APPLICATION NO.	FILING DATE	FIRST NAMED INVENTOR	ATTORNEY DOCKET NO.	CONFIRMATION NO.
10/785,164	02/20/2004	Mo Liu	AMI-2707	8517

**Advisory Action
Before the Filing of an Appeal Brief**

ANNOTATED DRAWING SHEET

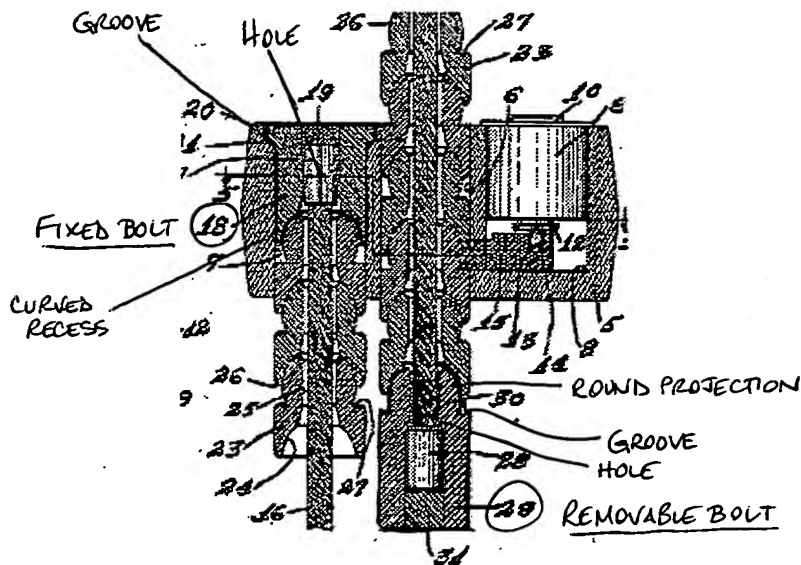
Continuation of 11. does NOT place the application in condition for allowance because: The Johnson references are deemed to teach the claimed structure of the fixed bolt and removable bolt (see the attached annotated drawing figures of Johnson '259 and '965).
